Amphenol BCO - Hill Site

**Village of Sidney, Delaware County
Site Number 413003**

Record of Decision

**Prepared by:
NEW YORK STATE
DEPARTMENT OF ENVIRONMENTAL CONSERVATION
Region 4, 2176 Guilderland Avenue, Schenectady, N Y 12306
THOMAS C. JORLING, Commissioner**

Figure 1 Monitoring Locations

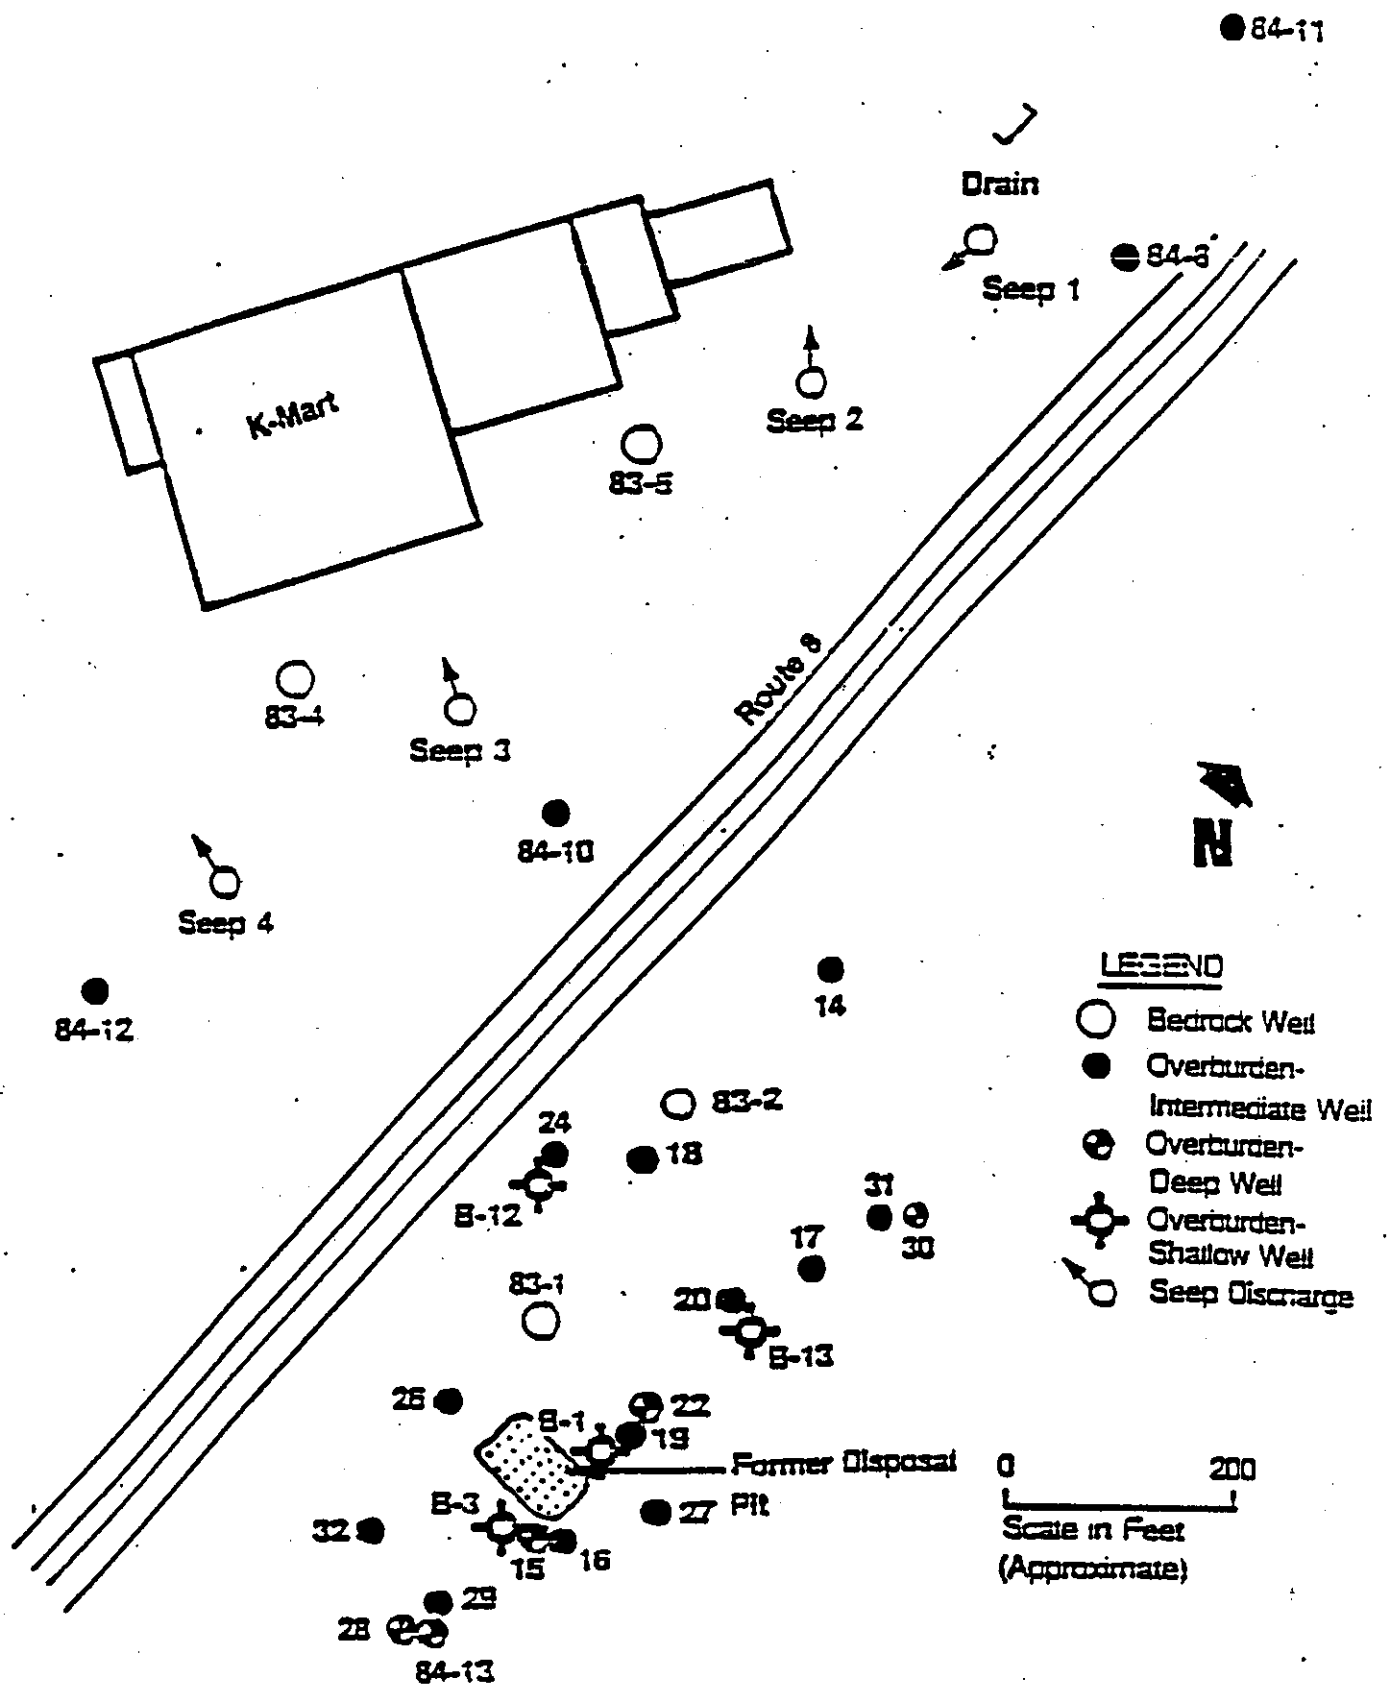
12. Do you have any wells outside the area of contamination?

Response: Referring to the map showing well locations, well 31 and well 84-8 are clean; well 29 is clean, because all constituents are below drinking water standards.

Figure 2
Ground Water Contour Map
Intermediate Glacial Flow Component
17 September 1992

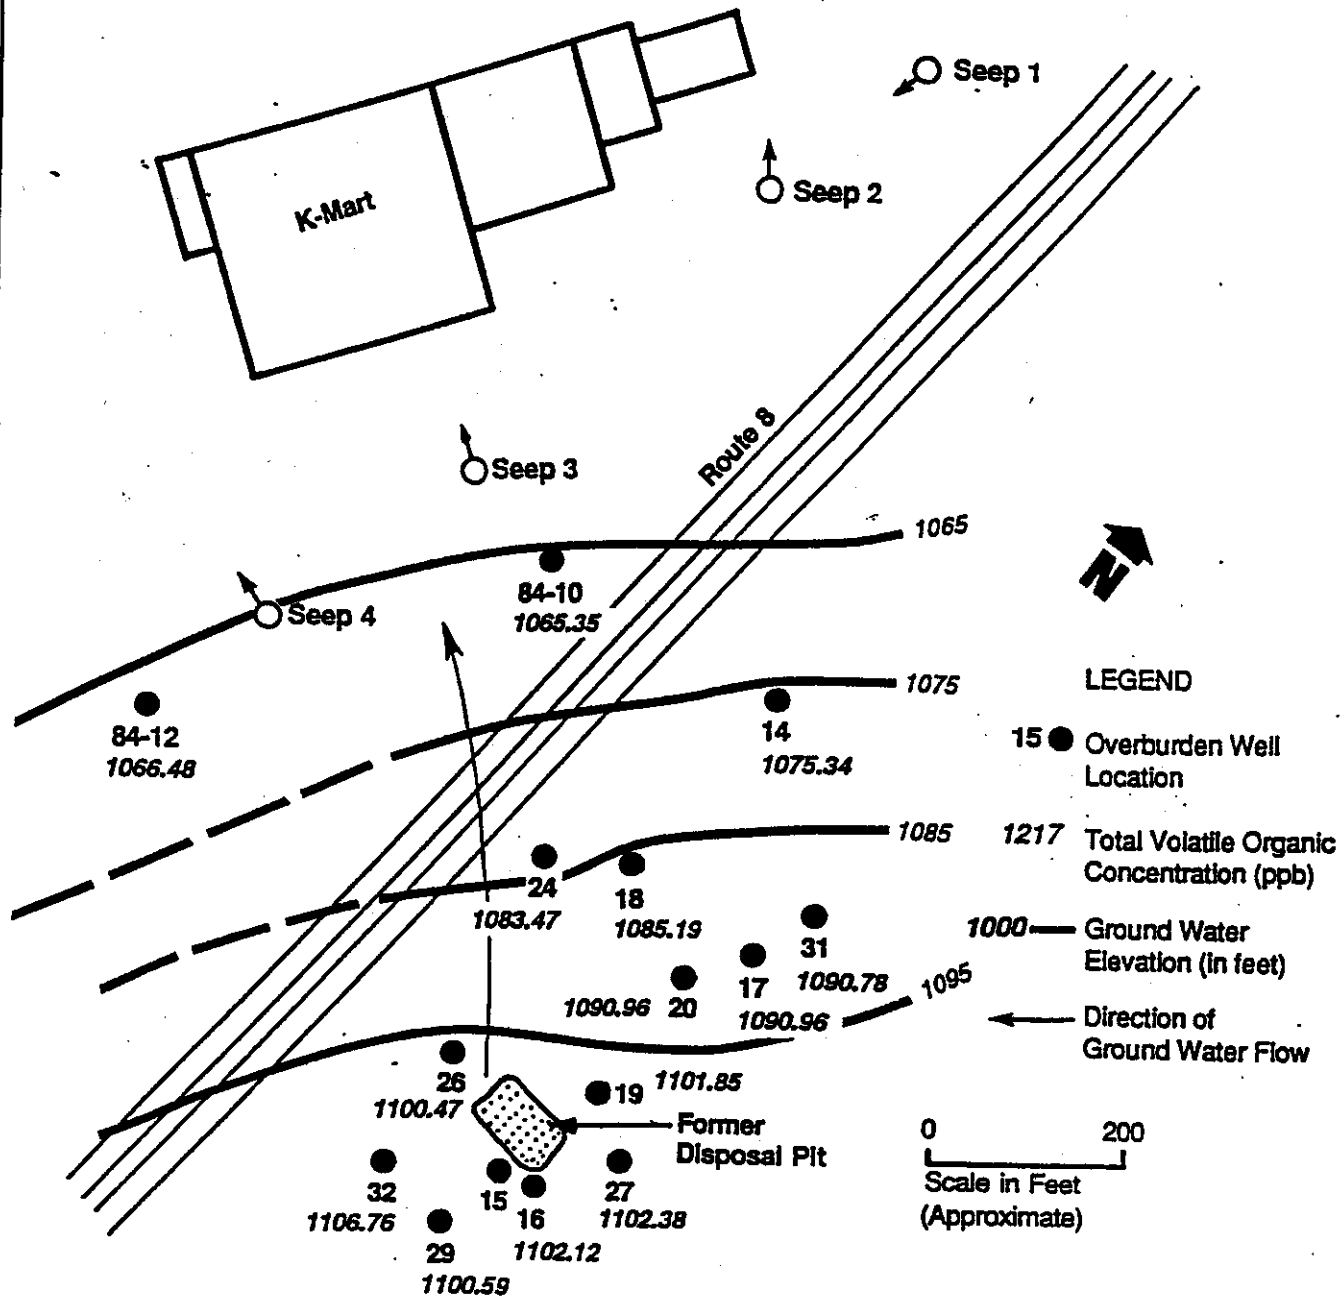
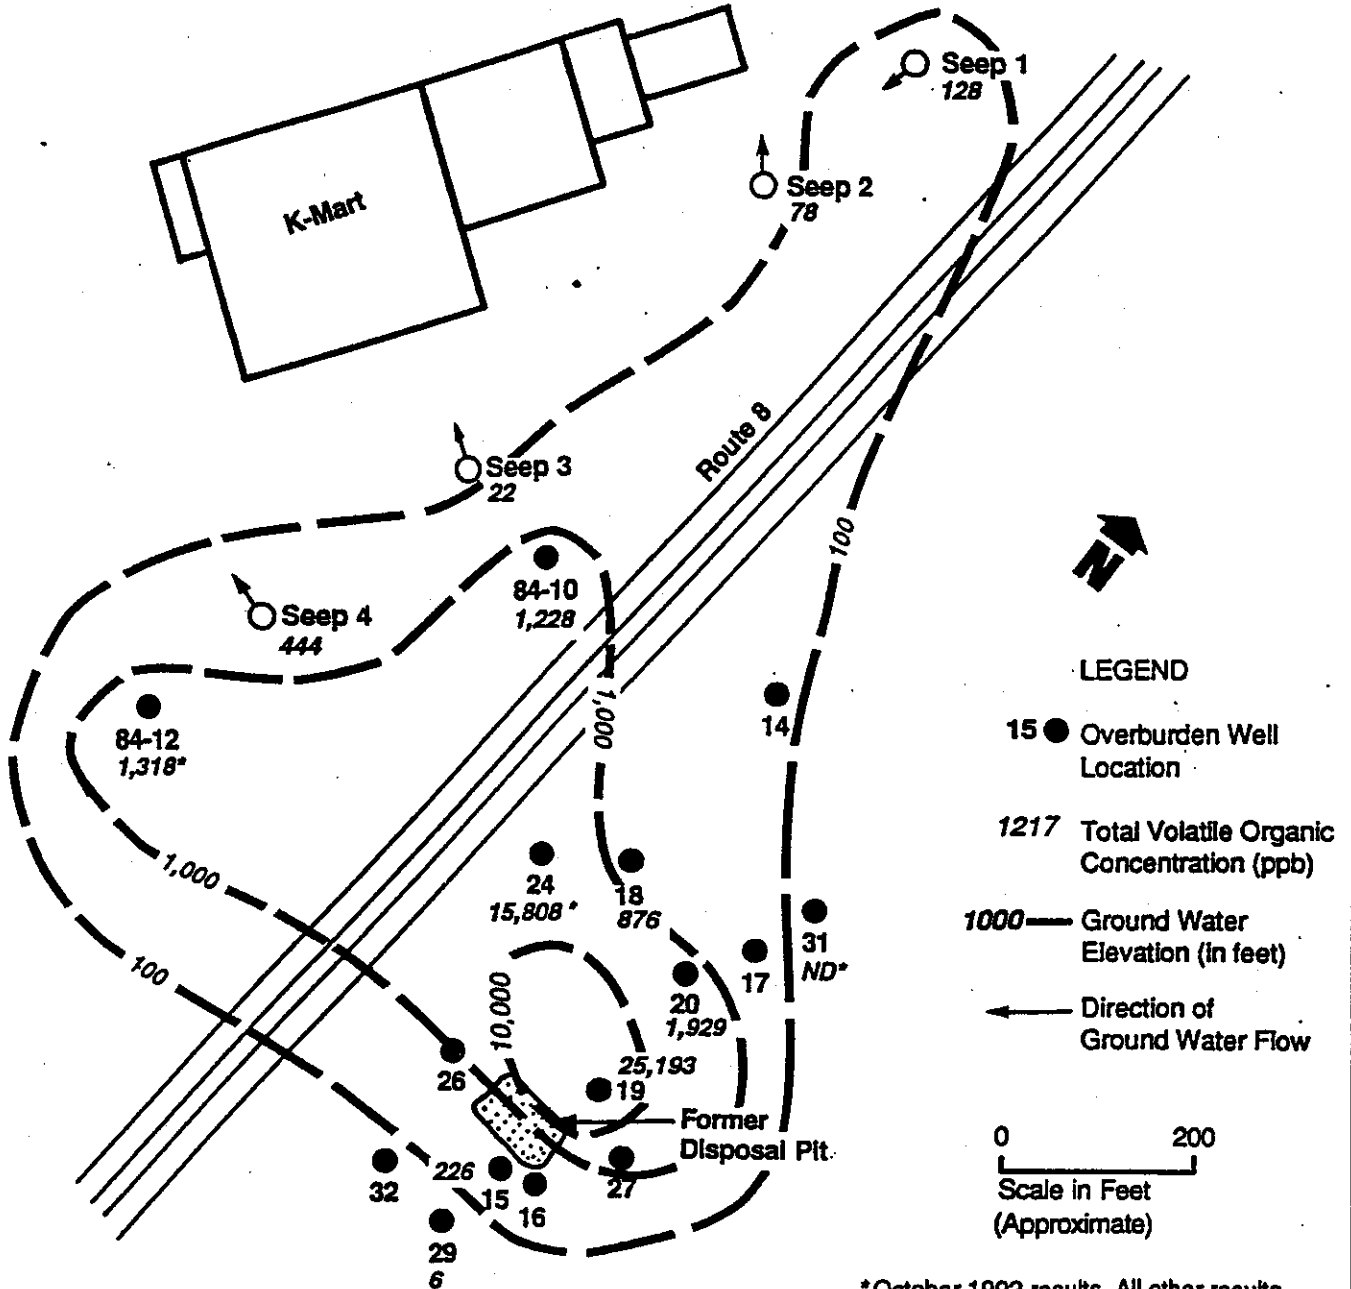
2. a. There was a spring at the end of Camp Street that was contaminated and dug up many years ago?
b. Has a study been made of the wet land to the east of the site, but north of Interstate 88 as shown on the USGS map?
c. There is a 200+foot deep well at the rectangle shown in the middle of the village on the USGS map. Would contamination be anticipated here?

Response: Referring to figure 2 in the proposed remedial action plan (PRAP) one can see that groundwater flows in a north northwesterly (NNW) direction. This is not in the direction of the Camp Road Spring, the wetland, or the well in the middle of the Village. Speculation is that the Camp Road spring may have been abandoned because of bacterial concerns. The Gifford Road spring to the NNW is being addressed in the Route 8 Landfill remediation. This will be intercepted and treated.
